Ulkatcho First Nation

Environmental Assessment Review *New Gold Blackwater Gold Project*

FIRST DRAFT – FOR DISCUSSION PURPOSES

February 10, 2016

Figure 3-31: Waste Rock Cumulative Frequency Plot and Humidity Cell NPR Values

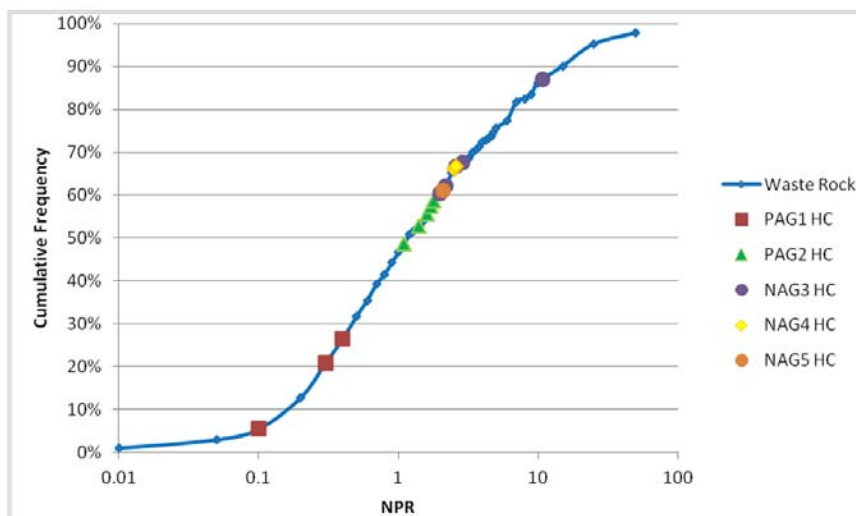
Of note is that within the humidity cell sample set, there is only one NAG 5 sample and two NAG 4 samples. These samples are meant to represent all of the on-land waste rock and construction rock. There is no overburden sample included in the dataset. This introduces some uncertainty into the source term predictions based on this component of work (discussed more below).

Figure 3-34: Waste Rock Humidity Cell pH values

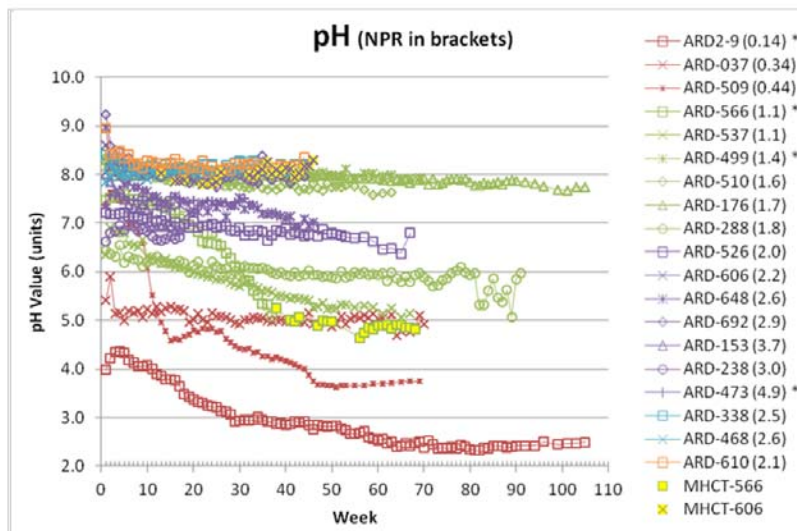
Testing shows that PAG samples can become acidic quickly. The proponent has acknowledged this within the context of the waste management plan with the objective to submerge all PAG rock within the first year of being excavated in order to minimize oxidation. This appears to be an appropriate approach though there remains a risk that some acidity and soluble metal loads could be generated within at last portions of the PAG rock prior to submergence.

Figure 3-43: Waste Rock Humidity Cell Arsenic Loads

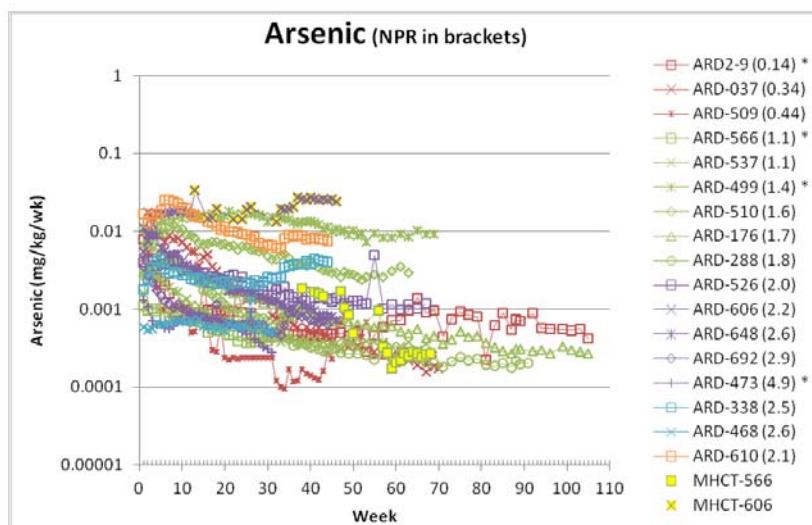
The humidity cell results for the NAG 5 sample generally showed low metal release rates with the exception perhaps of arsenic that was relatively high in the NAG 5 sample compared to others (see Figure 3-43 copied below, samples ARD-610).

Figure 3-57: Waste Rock Kinetic Field Bin Sulphate Loads

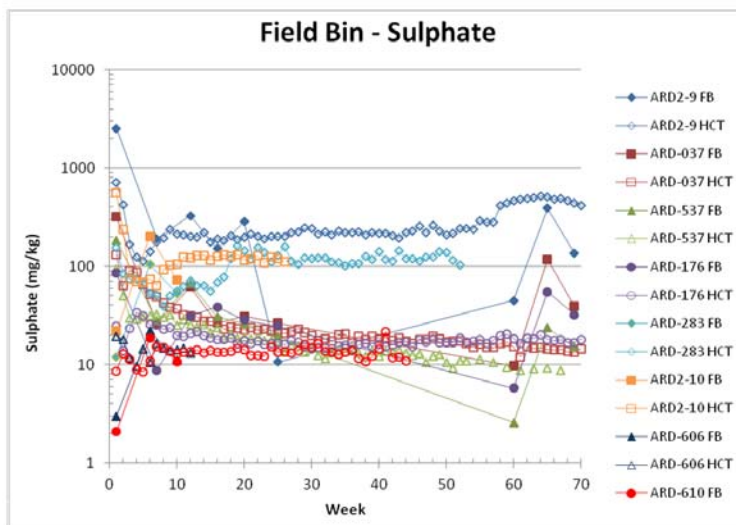
The proponent has initiated small field bins as another component of the kinetic test which, while at early stages of testing, will provide valuable information as time goes on. It was not clear how concentrations were converted to loads in the field bins. Often the flow component is difficult to measure and quantify in the field and can be a source of uncertainty in field bin load estimates. Can NG provide details on that calculation?

Figure 5-4: Block Model – ARD Classification of Ultimate Pit Walls

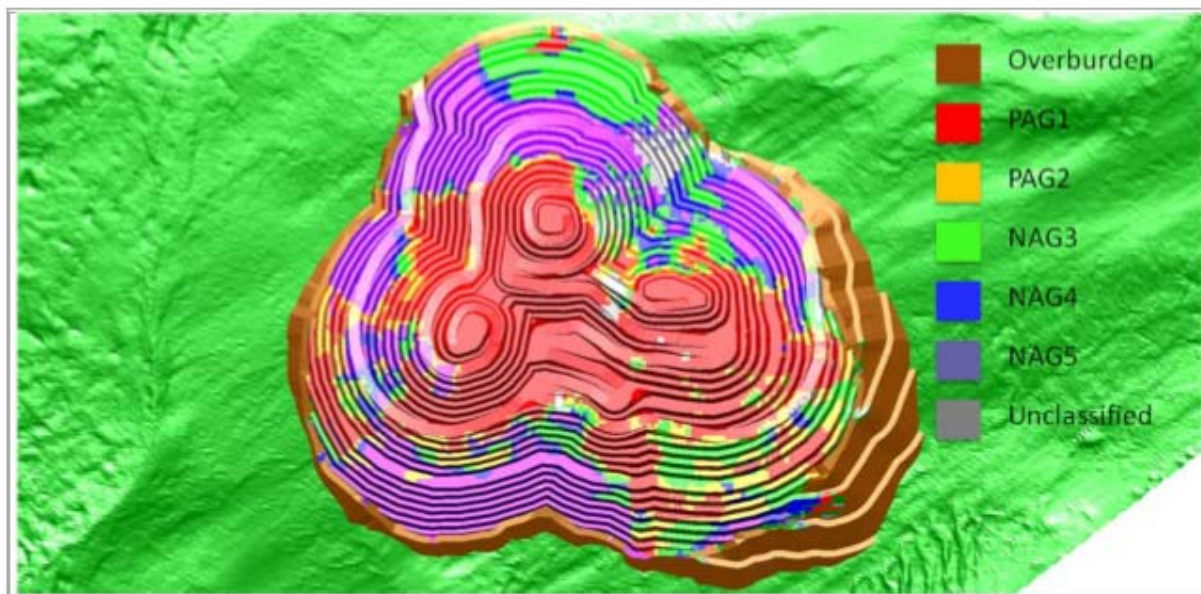
Zones that are largely purple – NAG 5 andesite are probably easily segregated, but blocks of NAG 4 so close to the NAG 3 and PAG blocks may be more difficult to separate.

Figure 3-53: Subaqueous Waste Rock Leachate Column Arsenic Loads

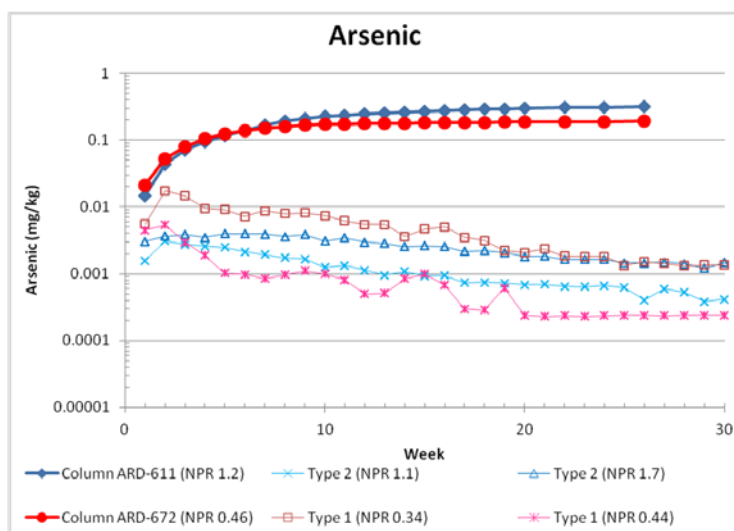
- Scaling lab data to field data was done in part on the basis of reactive surface areas. It is not explained exactly how this was done and what were the assumptions. The assumed reactive surface area for rock appears low which would result in low predicted source term concentrations. The proponent should describe in detail how that scaling was completed and what assumptions were included in the assumed rock surface area as it has a significant influence on the predicted source terms.
- It appears the predicted interstitial pore water in the submerged rock was low. It is unclear how this was integrated into the larger water quality model. A few parameters had higher release rates in the sub-aqueous columns than in the humidity cells for similar samples. Of particular note was the release of arsenic in the subaqueous rock. Was this accounted for?
